WCAP-17236-NP, Rev. 0

Subject: Pressurized Water Reactor Owners Group
Responses to the NRC Supplemental Request for Additional Information (RAI) on PWR Owners Group (PWROG) WCAP-17236-NP, Revision 0 "Risk Informed Extension of the Reactor Vessel Nozzle Inservice Inspection Interval" (TAC NO. ME4878) PA-MS-C-0440

Subject: Response to NRC Request for Additional Information and Mark-Up Pages for WCAP-17236-NP, Revision 0, "Risk-Informed Extension of the Reactor Vessel Nozzle Inservice Inspection Interval"

Figure DCI-RAI-2-1 – Leak Rate Program Calculations (from Reference 4)

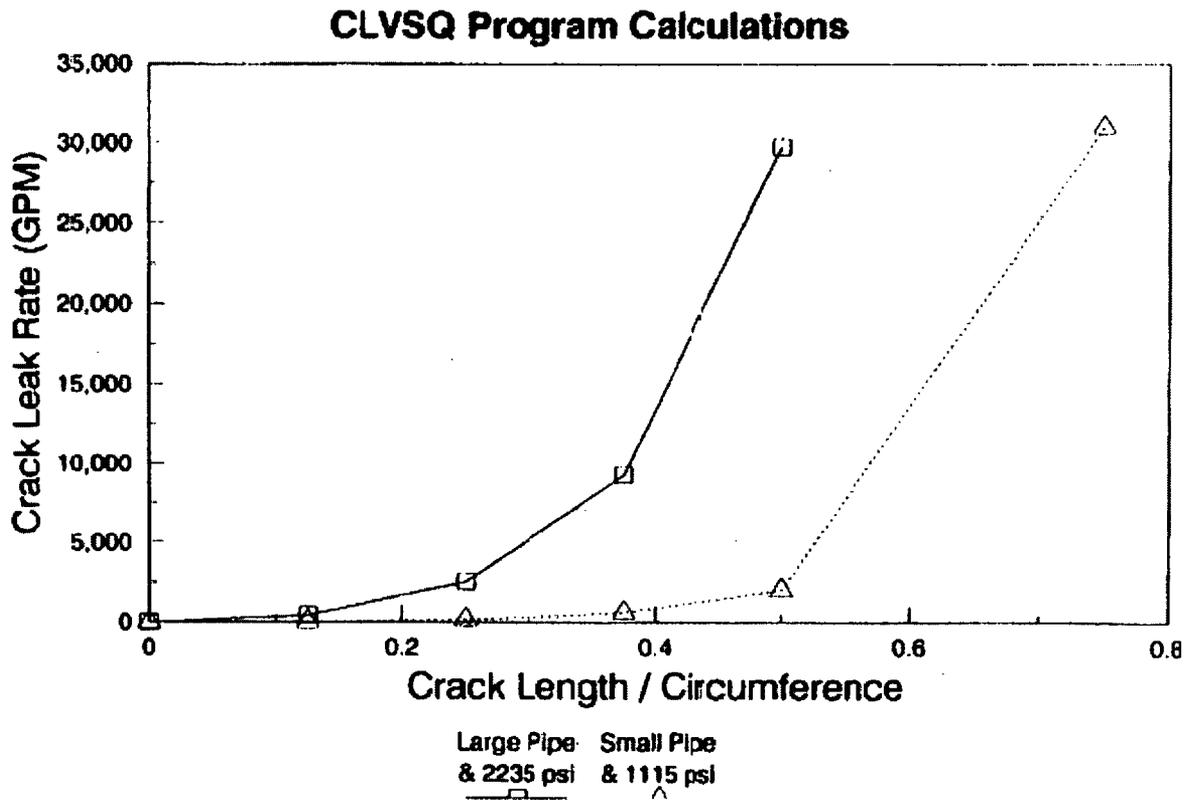
DCI-RAI-2 *Section 2.4.1 of TR WCAP-17236 mentions that "the calculations are performed using the change in failure frequencies with credit for leak detection." Provide a summary of the PFM analysis methodology used in TR WCAP-17236, including:*

The PFM methodology used to calculate the change in failure frequencies with credit for leak detection is summarized as follows:

4. To calculate the failure probabilities for the failure modes of specified leak rates, such as a small-break loss-of-coolant accident (LOCA), a medium or large-break LOCA or the effects of leak detection on a full break due to ductile rupture, the pre-processor program CLVSQ is used. CLVSQ stands for crack length versus the leak flow Q, and typical calculated results are shown in Figure DCI-RAI-2-1 (Figure 2-4 in the SRRA Supplement, Reference 4). The crack flow rate, dQ/dt , in gallons per minute (GPM) is calculated in CLVSQ using the equation:

Where P is pressure in psi, A is the crack opening area in square inches, and w is the weld wall thickness in inches. This equation is based upon calculated results from the pc-PRAISE Code (NUREG/CR-5864, LLNL, 1992) with an improved leak leak-rate model similar to that in the PICEP Computer Code contained in the 1984 EPRI Report, NP-3596-SR. The constant value of 0.06 in the equation was derived for the improved pc-PRAISE results for five different sets of pipe sizes and operating conditions. However, the base case was for large-diameter piping welds at PWR reactor coolant system (RCS) operating conditions that would be directly applicable to the RV nozzle-to-pipe welds. The CLVSQ program also requires weld material properties for calculating the crack opening area as a function of crack length for the applied pressure, deadweight and thermal stresses per the elastic-plastic analysis methods contained in the 1984 EPRI Report NP-3607. Specifically, the crack opening displacement is calculated by numerically integrating the plastic stress intensity factor (J) along the length of the crack. The elastic-plastic weld material properties that are used in the CLVSQ program for type A-106B carbon and types 304 or 316 stainless steel, respectively, are the same as the default input values to the improved pc-PRAISE Code. Finally, the crack leak rates for small, medium, or large loss-of-coolant accidents (LOCA) are 100 GPM, 1,500 GPM and 5,000 GPM, respectively, per Sandia National Laboratory Report NUREG/CR-4550, Revision 1, Volume 1, 1990. A minimum detectable leak rate of 1 GPM is used based upon PWR plant Technical specifications for unidentified leakage.
